WORKSHOP AGENDA

Planning Commission

January 14, 2025 @ 5:30 PM

For the January 28, 2025 Regular Meeting @ 6:00 PM

PROJ. # 18314.55	DATE: 12-30-24 REV:	FILE: ARBOR RIDGE SEC 5 FINAL PLAT	DRAWN BY: ATS	SCALE: 1" = 50'	SHEET 2 OF 2
---------------------	------------------------	--	------------------	--------------------	-----------------

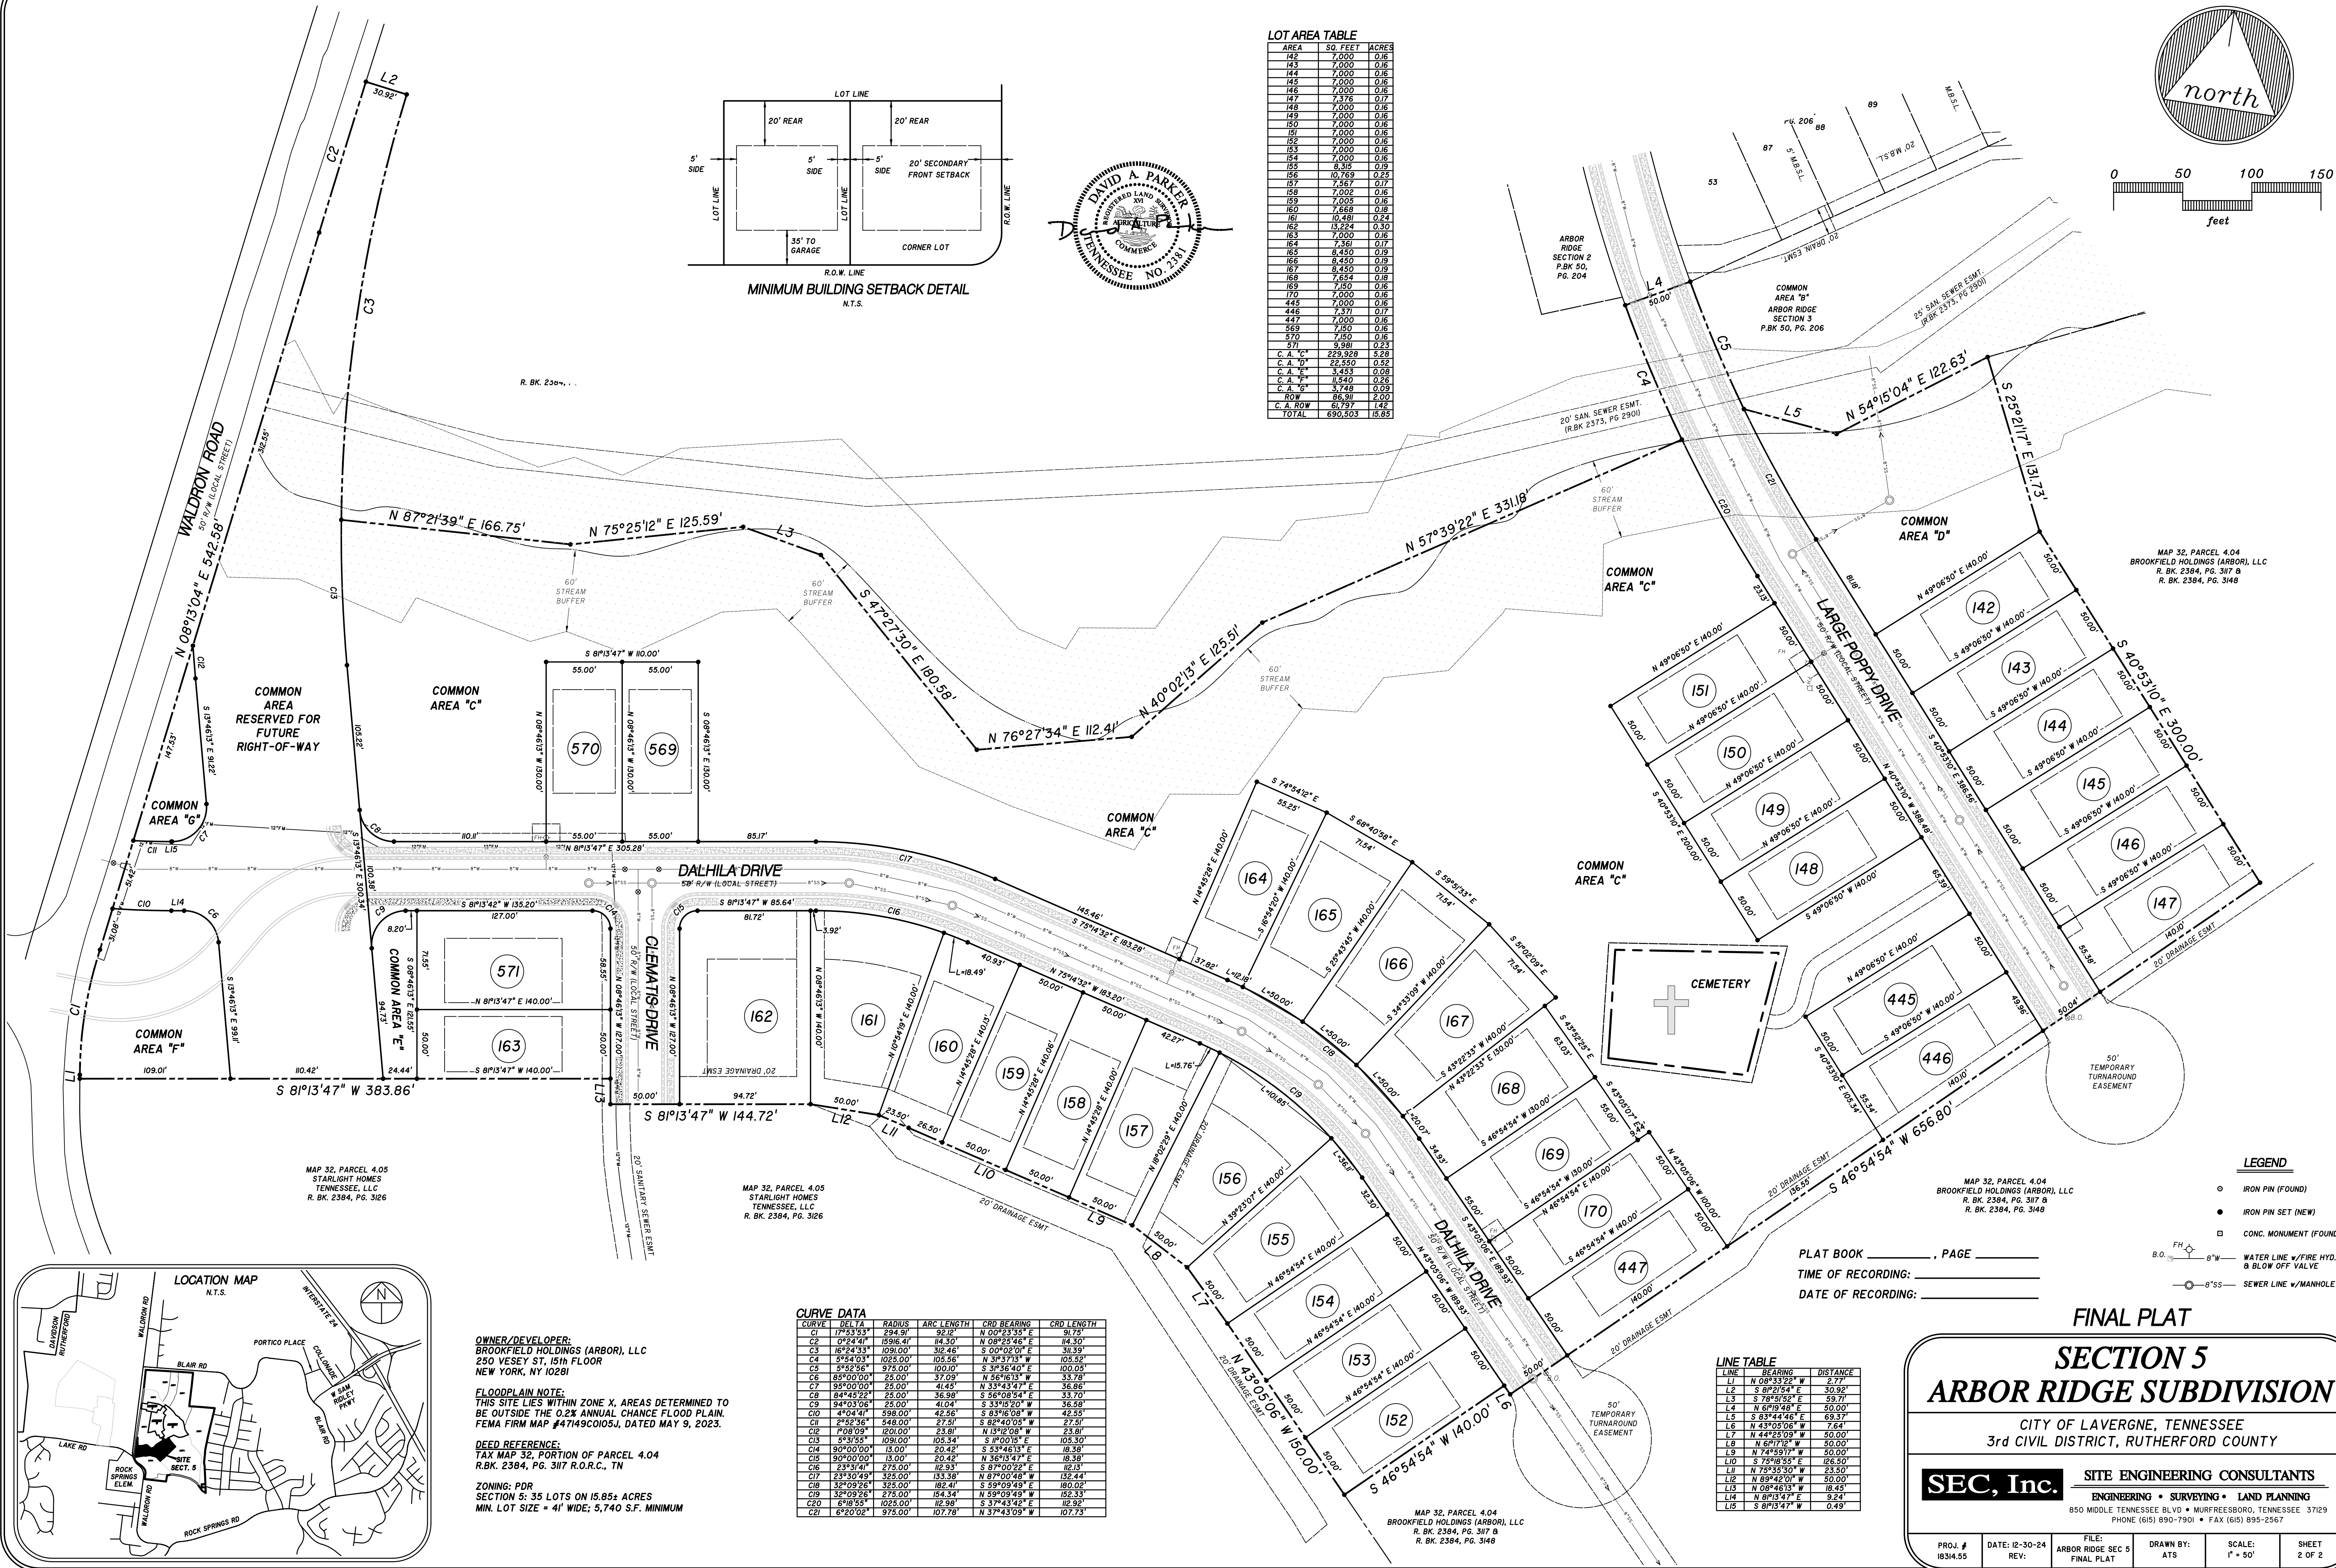
2. Correct size of City's public sewer FM shown near Waldron Rd and Dahlia Dr to 8-inch diameter (currently shown as 12 inch).
3. Correct spelling of Dahlia Dr (currently "DALHILA").

PROJ. # 1834.55	DATE: 12-30-24 REV:	FILE: ARBOR RIDGE SEC 10 FINAL PLAT	DRAWN BY: ATS	SCALE: 1" = 50'	SHEET 2 OF 3
--------------------	------------------------	---	------------------	--------------------	-----------------

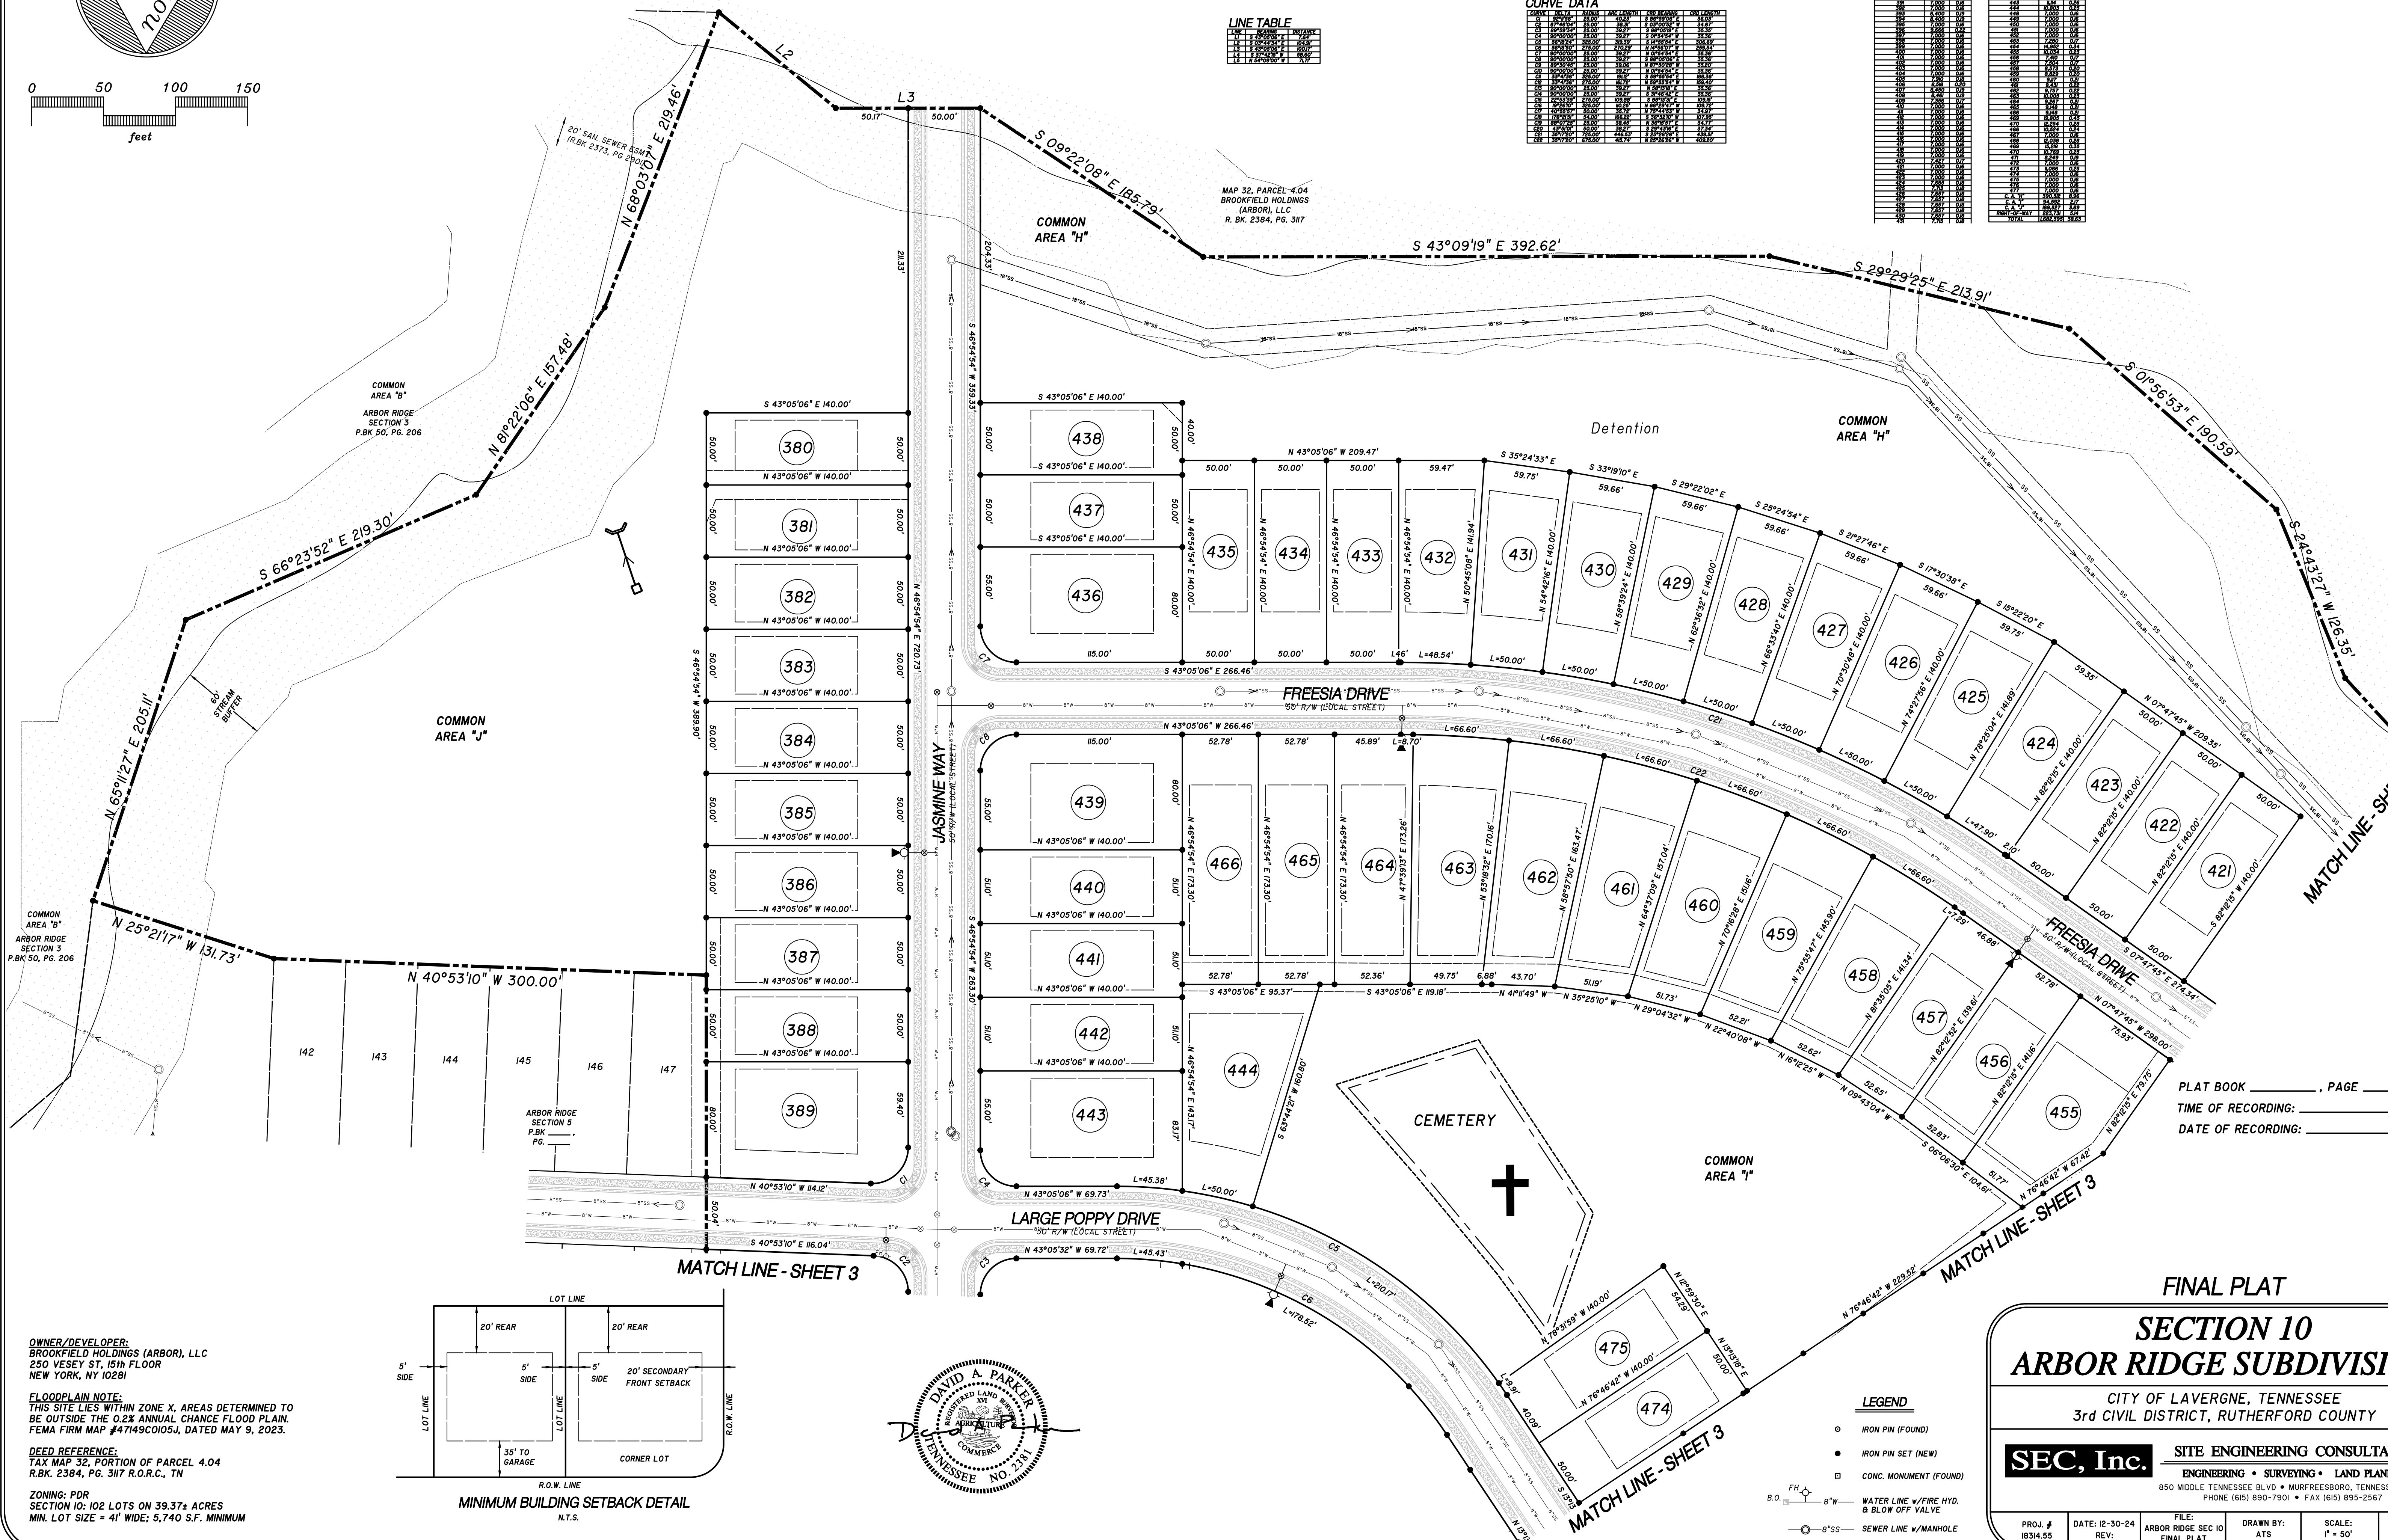
1. See comment 1 of Final Plat, Arbor Ridge Section 5 – same request for general note supplying 10-foot easements along all street right-of-ways.
2. Stormwater pipe, headwall, and easement is missing between lots 405 and 406.
3. Stormwater catches and pipes crossing streets are missing.
4. Stormwater easement behind lots 468-480 on Jasmine Way is missing (shown on TDEC plans). May want to check to verify all your needed stormwater layers are on in CAD for this plat.

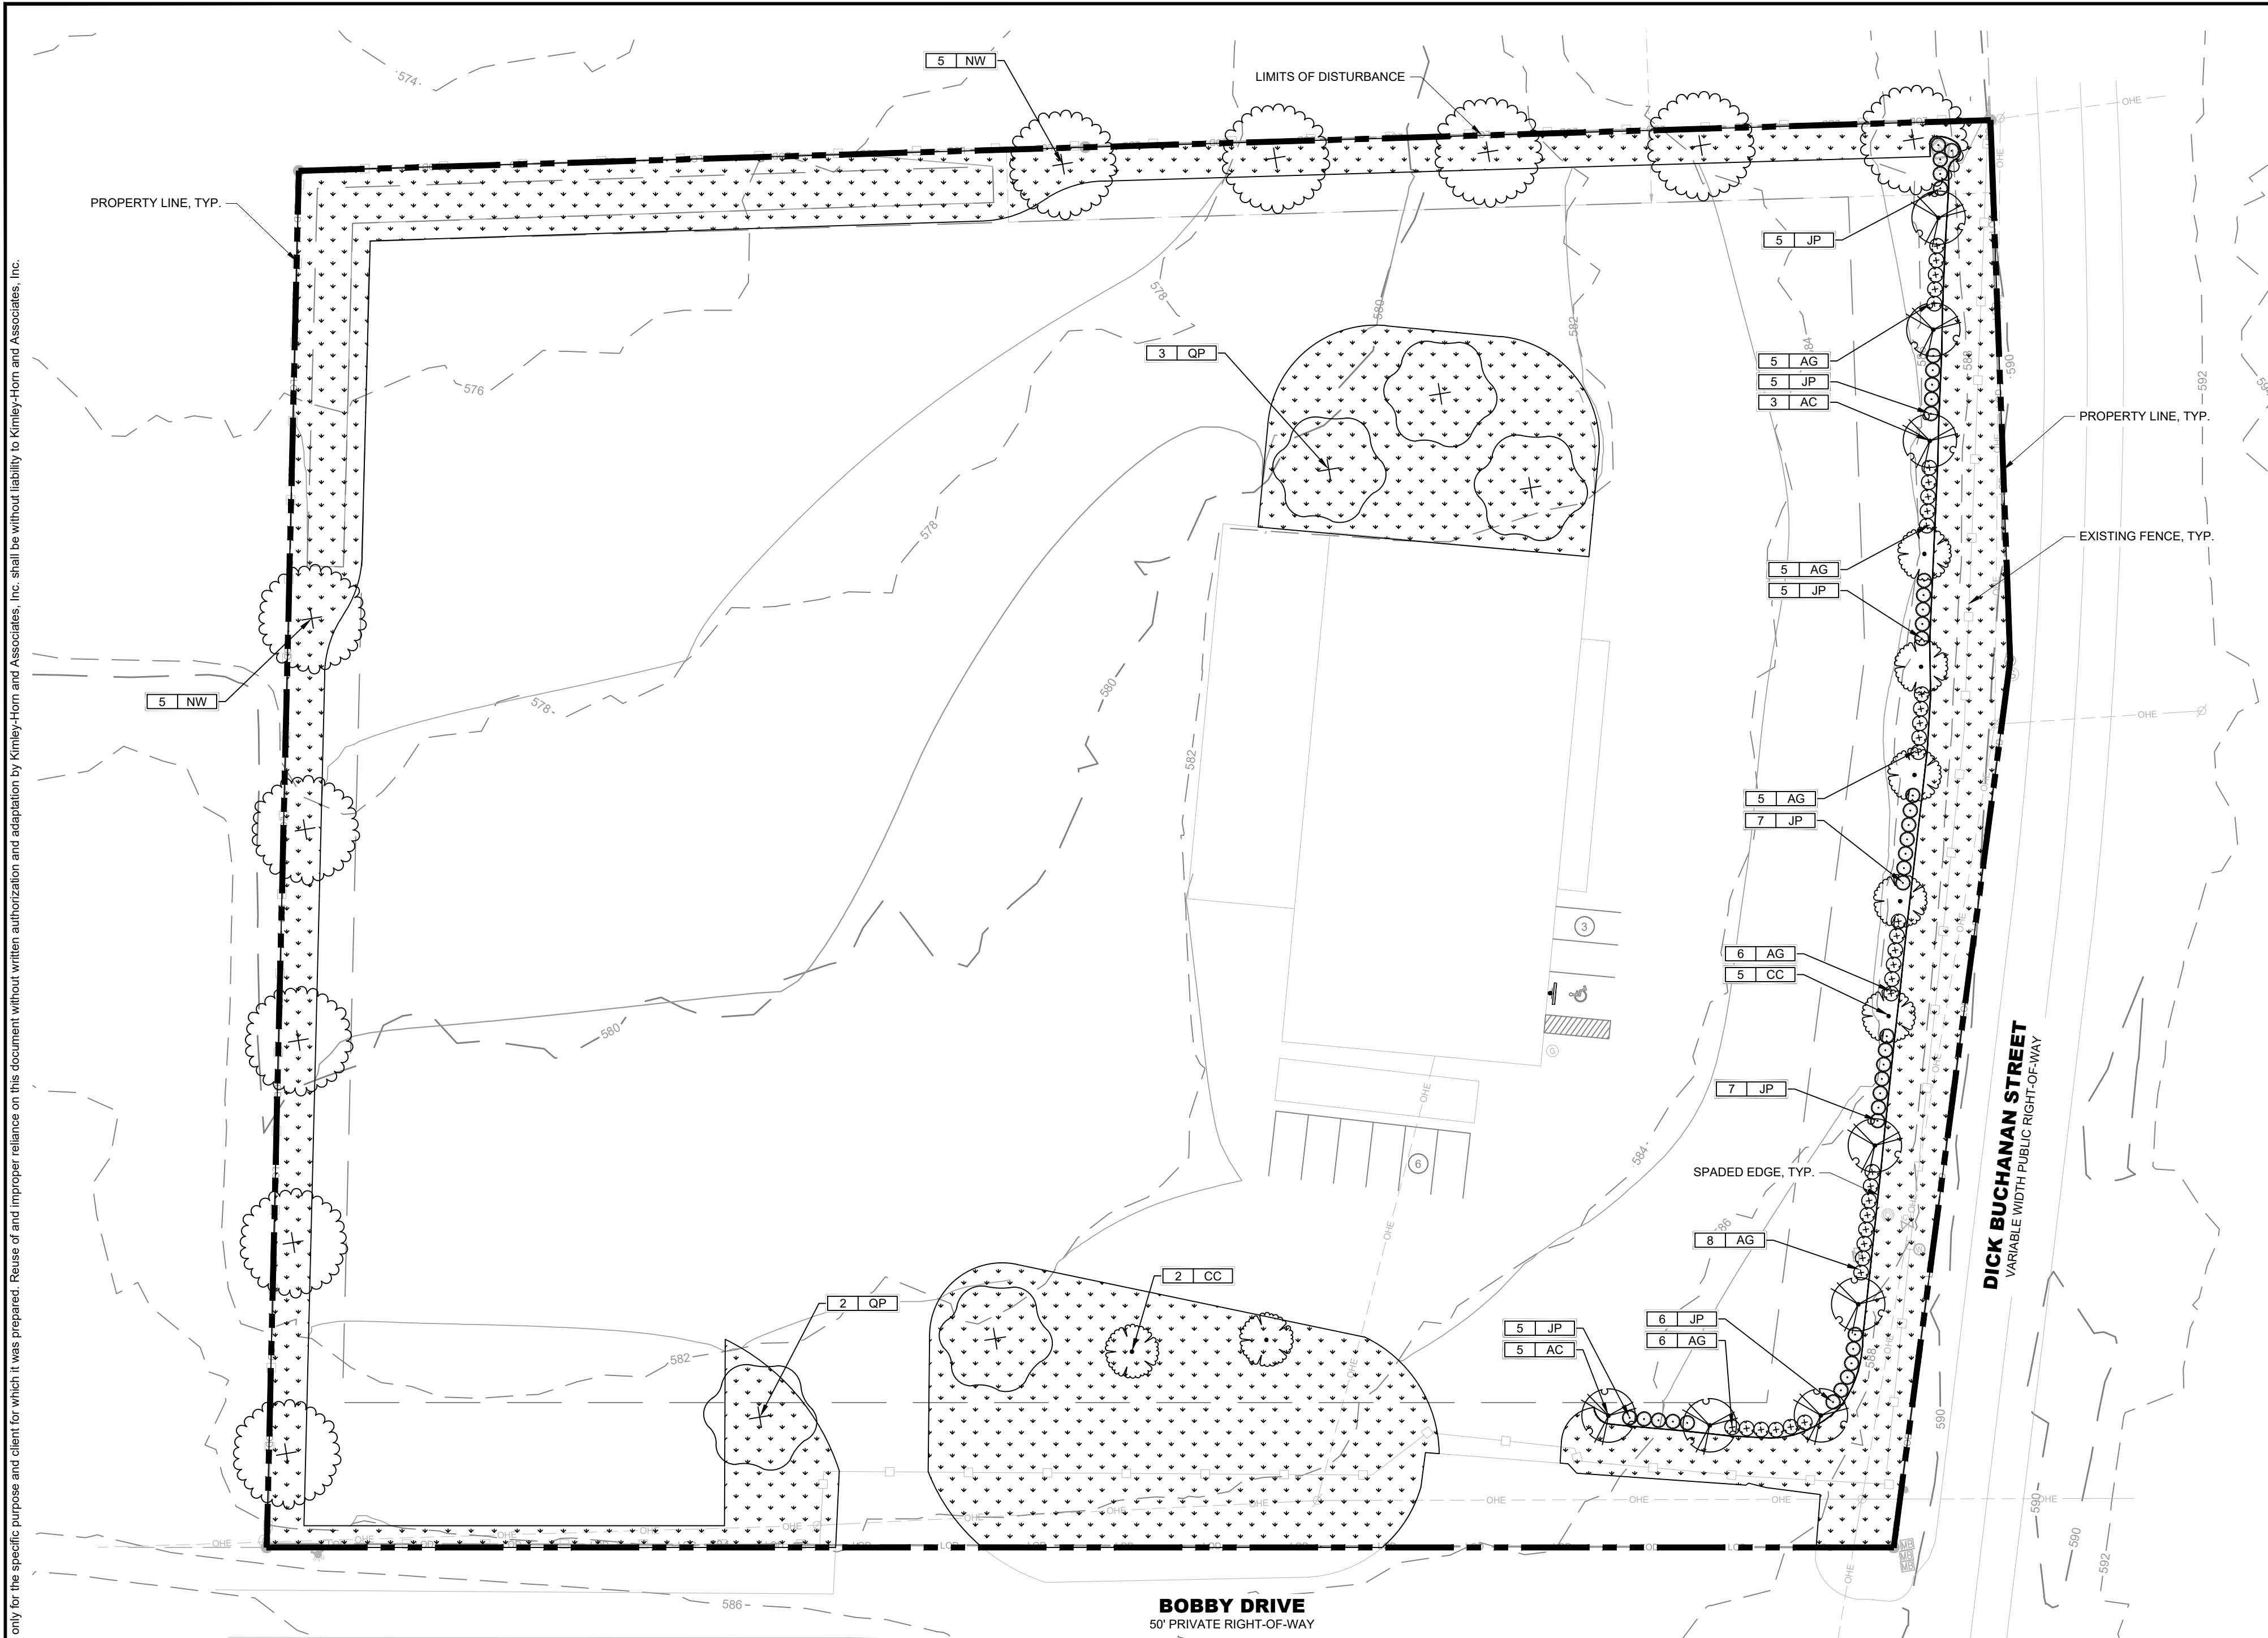
1. Please show expected routing of onsite water and sewer private plumbing services.
2. Sht L1-00, Landscape Plan shows plantings along the perimeter. Some of these may be right over the existing water and sewer plumbing services, which could be damaged if not labeled or shown. City will not mark onsite private plumbing, only public utilities.
